REPORT ON

INSTALLATION OF EXTRACTION WELL EW-13 FOR
ON-SITE GROUNDWATER EXTRACTION SYSTEM
2221 NIAGARA FALLS BOULEVARD
WHEATFIELD, NEW YORK

Design Clarifications/Modifications

2
B-3
GENERAL LAYOUT
EXTRACTION WELL EW-13
PLAN VIEW
NOT TO SCALE

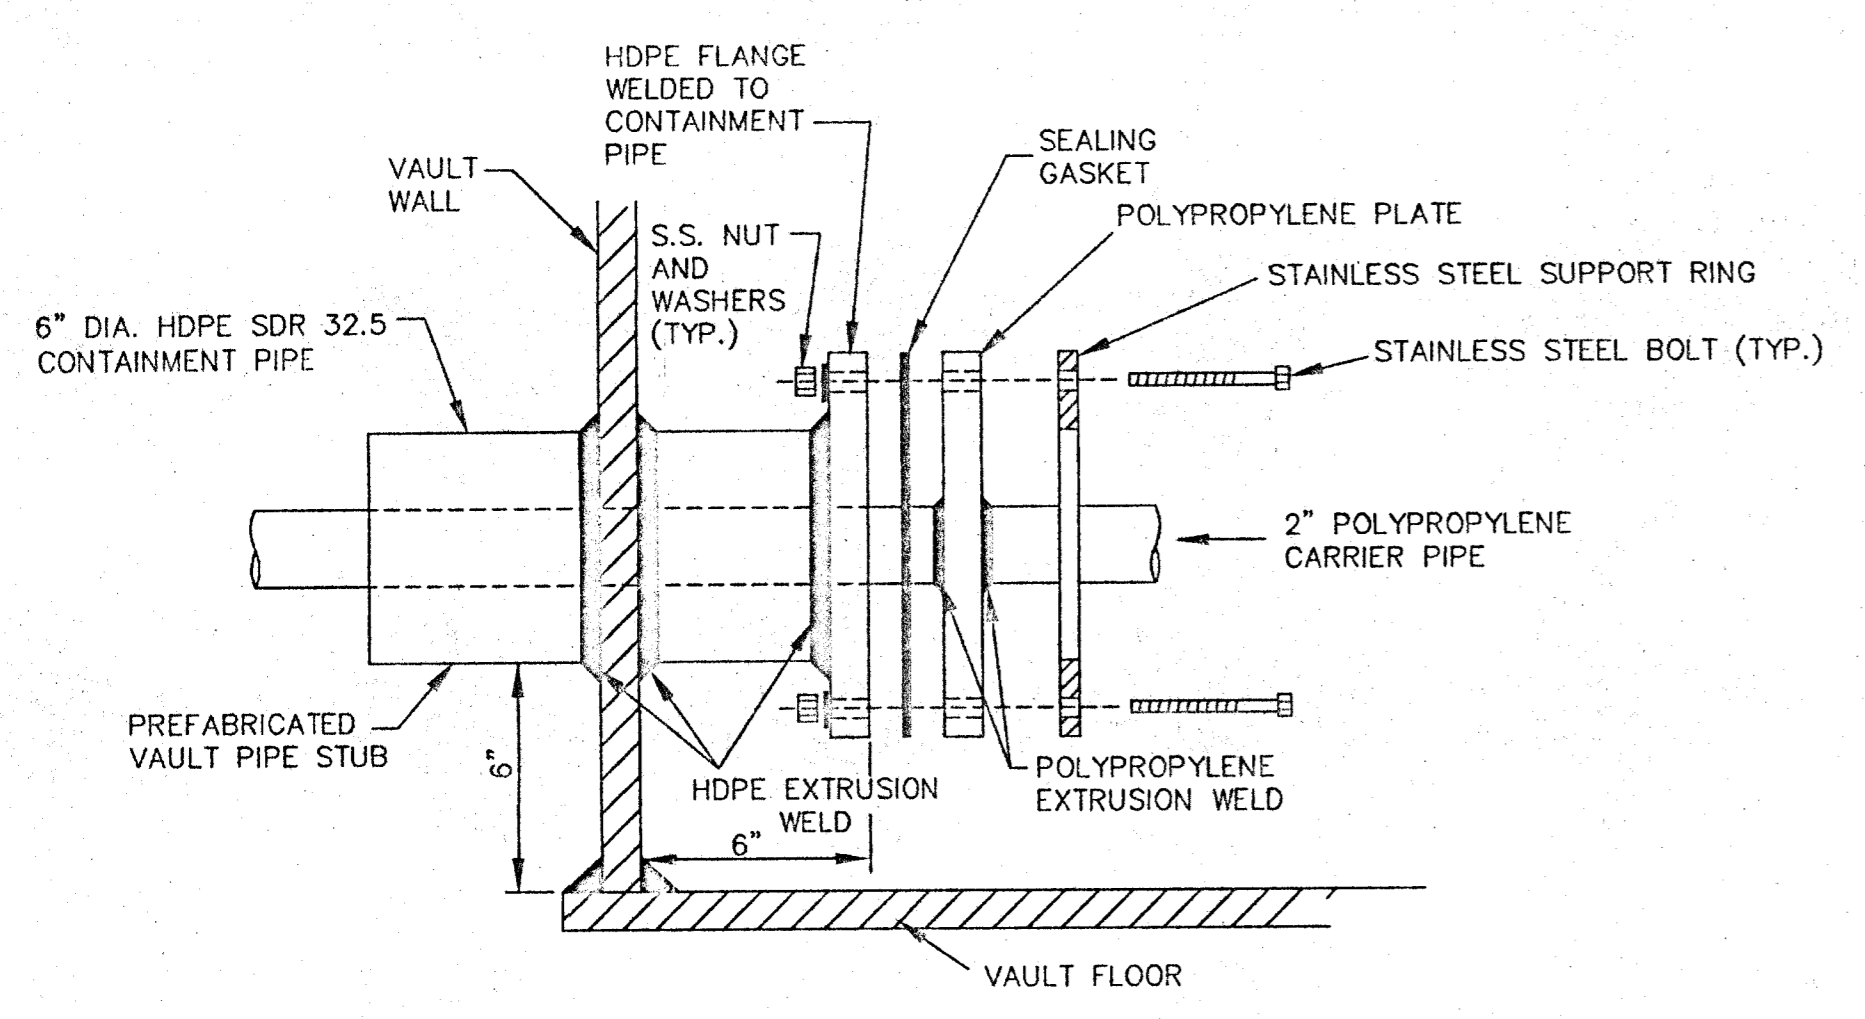
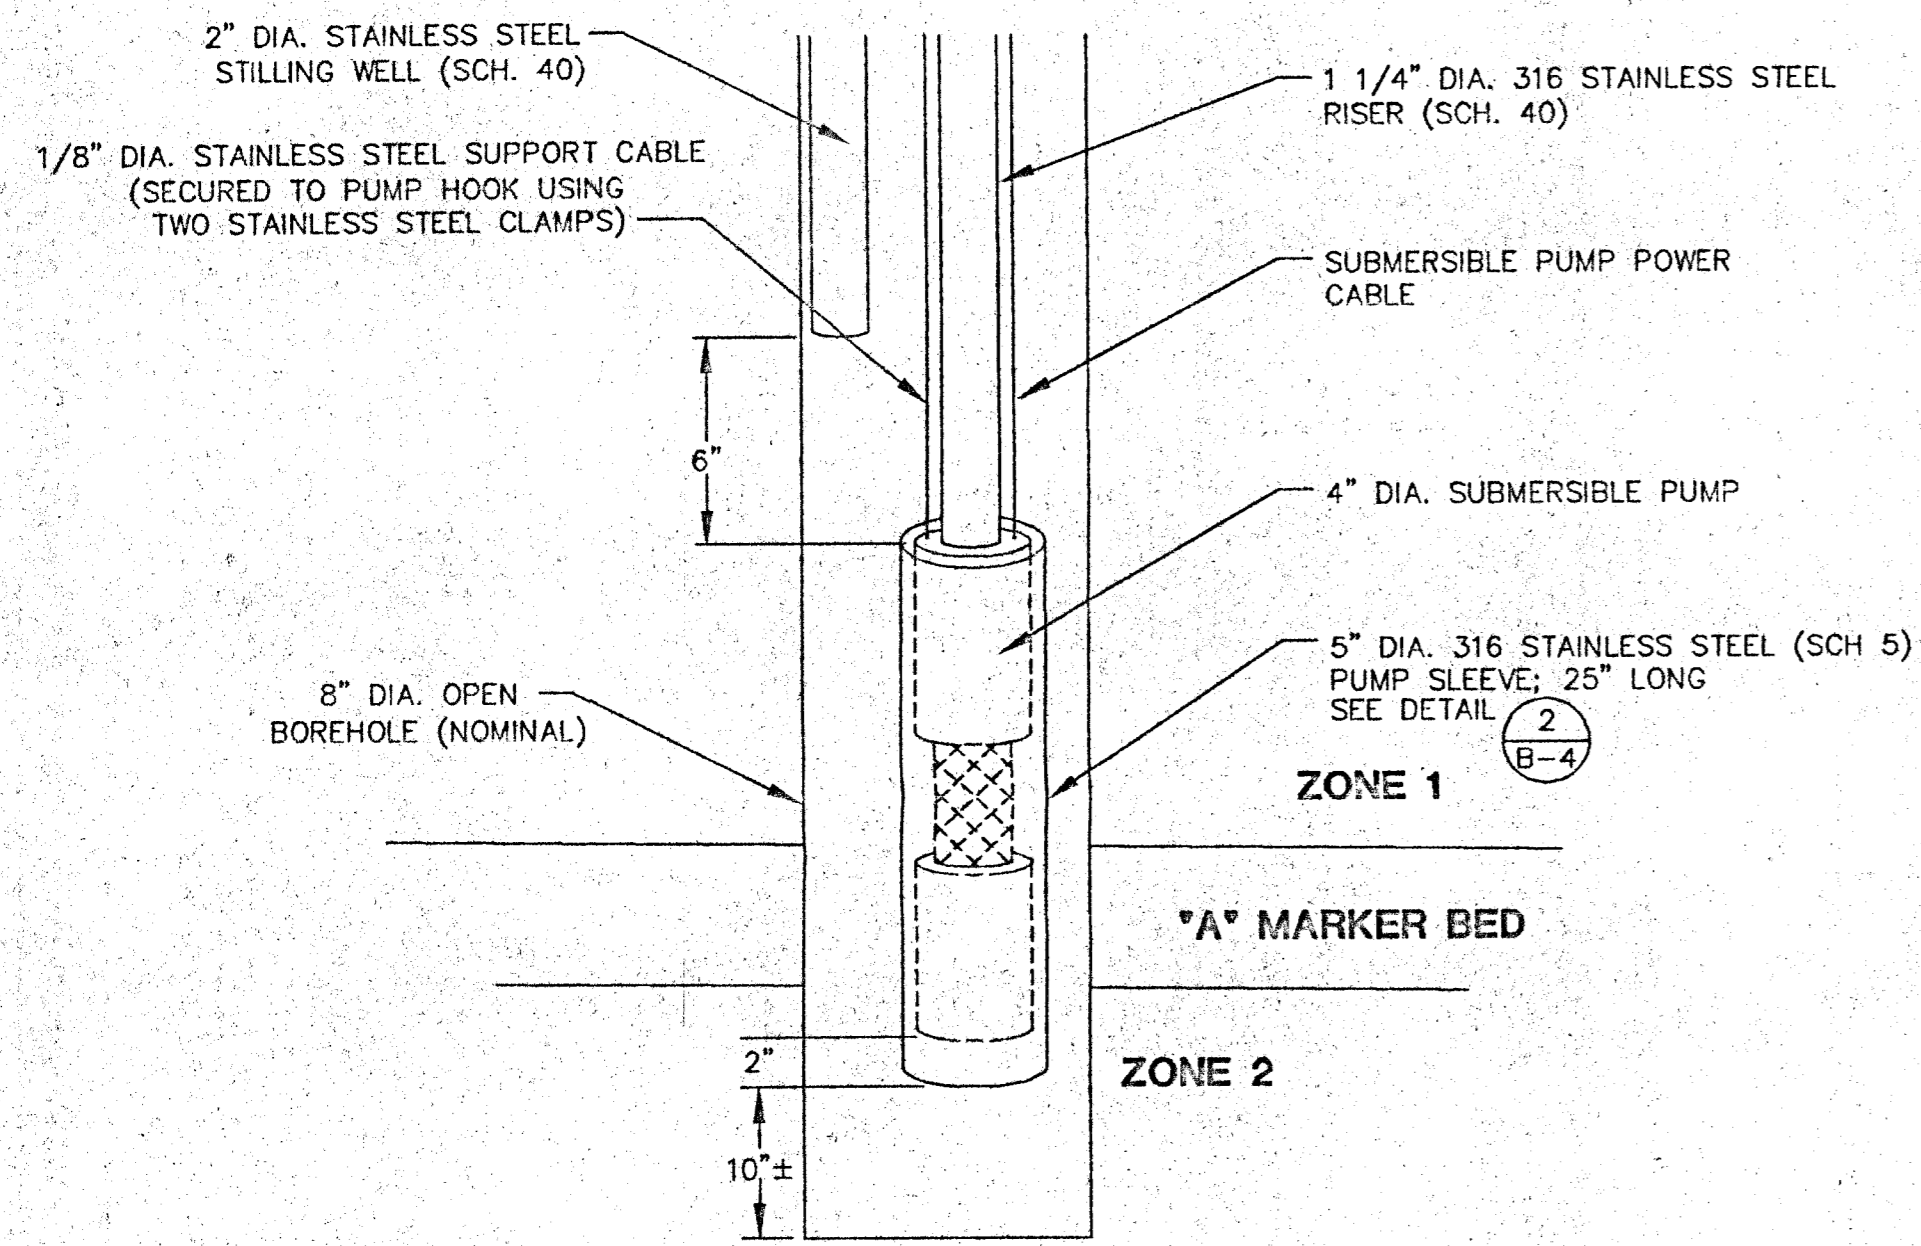
LOCATION / REFERENCE OF MODIFICATION: Drawing details 2/B-3 and 1/B-4, and relevant
portions of Specifications.

MODIFICATION MADE: Standard dimensional ratio (SDR) of HDPE overburden casing changed
from SDR 17.6 as specified to SDR 11 which has thicker walls. Reduced inside diameter of this pipe
(approximately 8 inches) necessitated reducing the rock borehole diameter from 9 inches to 8 inches
and shortening the stilling well from 6 inches above the bottom of the pump sleeve to 6 inches above
the top of the pump sleeve. The above borehole diameter and stilling well configuration are
consistent with the design of the Off-Site Groundwater Extraction System.

LOCATION / REFERENCE OF MODIFICATION: Drawing detail 2/B-3 and relevant portions of
Specifications.

MODIFICATION MADE: NYSDOT #1A stone replaced by flowable (flyash) fill from approximately
one foot below the bottom of the 6-inch containment pipe to approximately 4-inches above the top of the pipe.
Modification applies only to the lower portion of the pipe, not that connecting EW-13 to the "T".

REMARKS: Modification made to better support pipe during backfill operations.

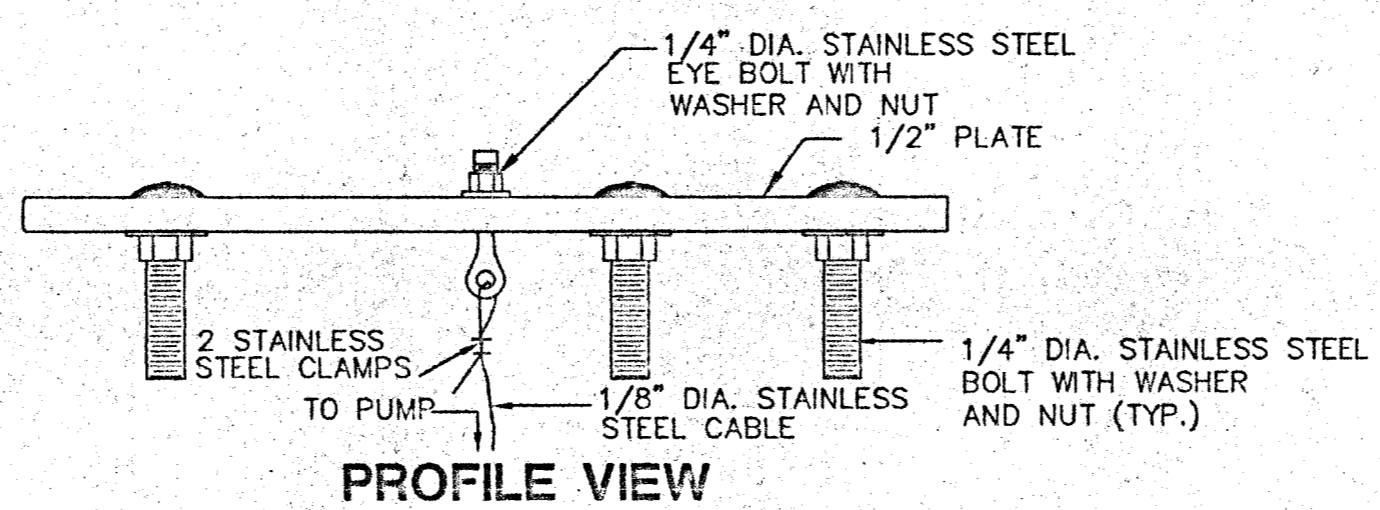
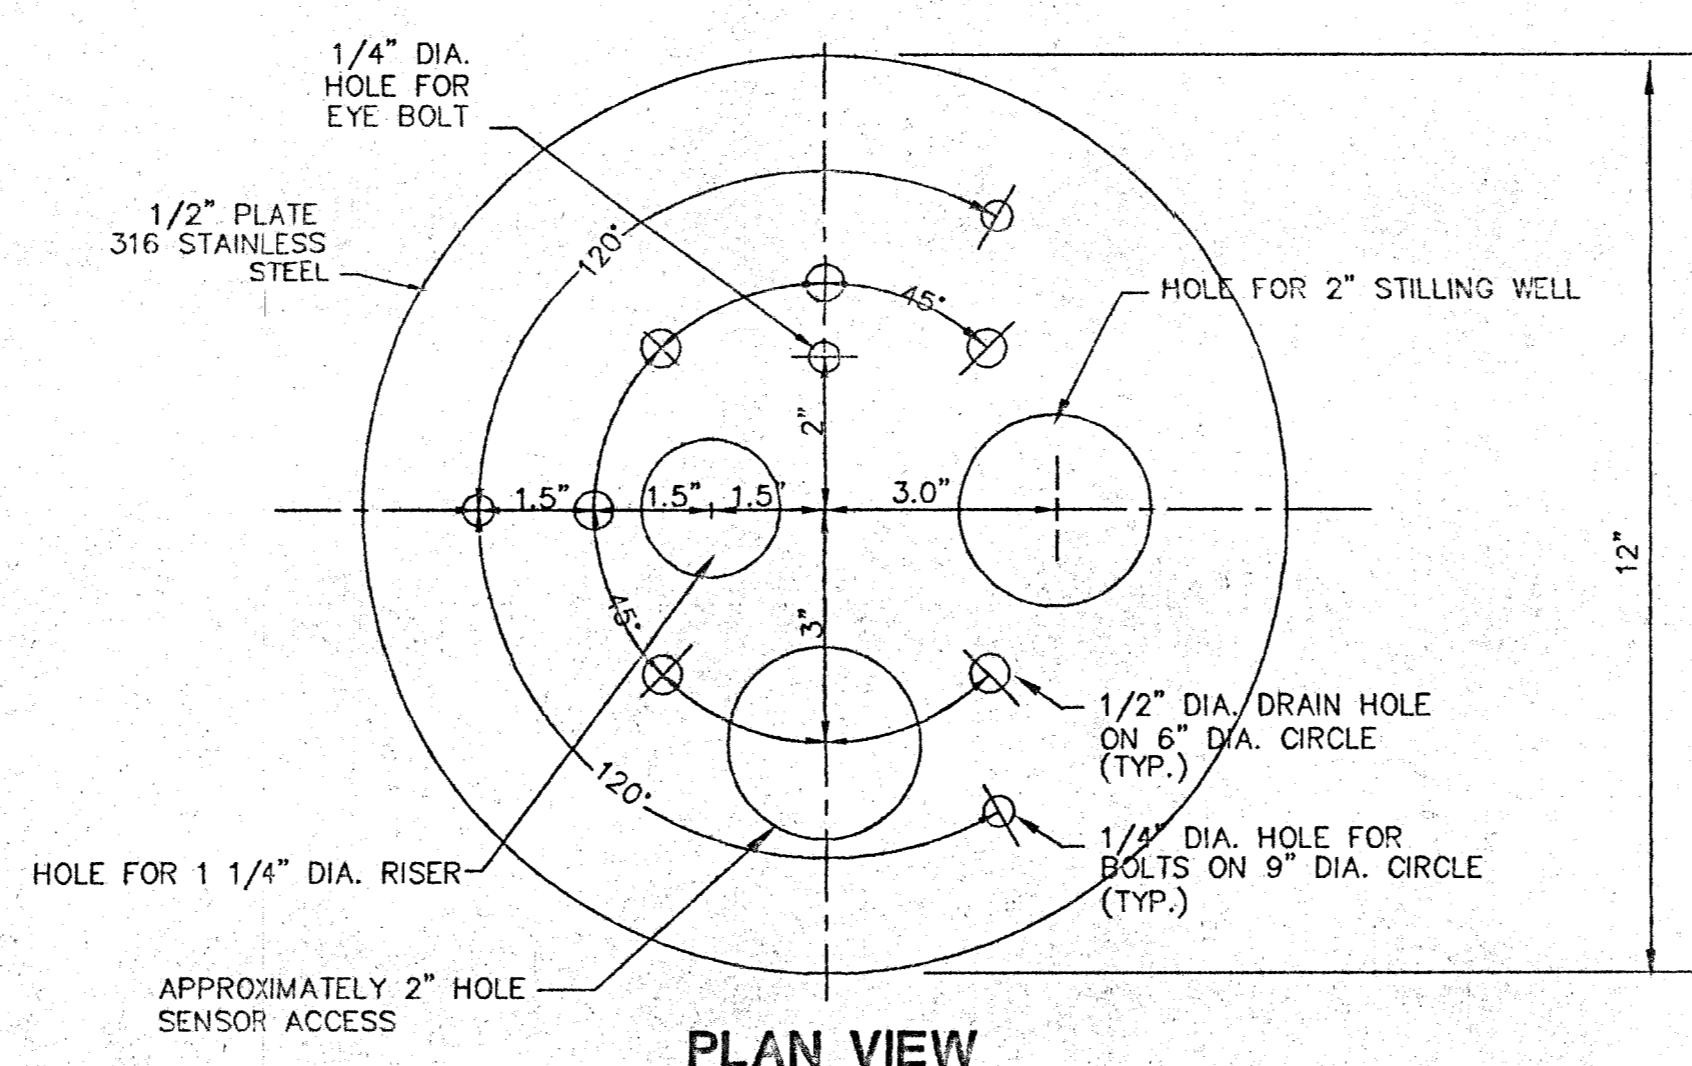
LOCATION / REFERENCE OF MODIFICATION: Drawing detail 2/B-3, and relevant portions
of Specifications.

MODIFICATION MADE: Butt-Fusion weld joining vault penetration piping to exterior piping
replaced by coupler weld as in detail 4/B-4.
